[Docket No. FAA-2012-0415; Directorate Identifier 2008-SW-065-AD; Amendment 39-17865; AD 2014-12-04]

Airworthiness Directives; Bell Helicopter Textron, Inc. (BHTI) Helicopters

ACTION: Final rule.

Figure 1 to Paragraphs (f)(2)(ii) and (f)(4)(ii)
Inspection of Main Rotor Hub Grip Tangs

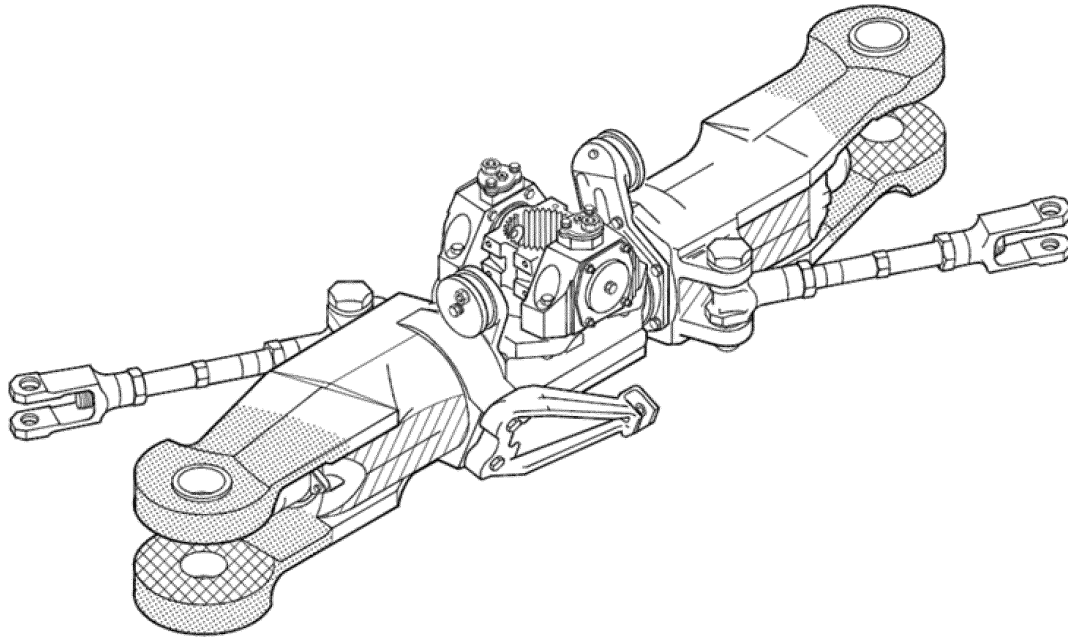
- (i) Clean the exposed surfaces of the upper and lower tangs of each grip with denatured alcohol, and wipe dry.
- (ii) Using a 10-power or higher magnifying glass, visually inspect the exposed surfaces of the upper and lower tangs of each grip for a crack. Pay particular attention to the lower surface of each lower grip tang from the main rotor blade bolt-bushing flange to the leading and trailing edge of each grip tang as depicted in Figure 1 to Paragraphs (f)(2)(i) and (f)(4)(ii) of this AD.

(ii) Inspect each grip buffer pad on the inner surfaces of each grip tang for delamination as depicted in Figure 1 to Paragraphs (f)(2)(ii) and (f)(4)(ii) of this AD. If there is any delamination, remove the buffer pad and inspect the grip surface for corrosion or other damage.
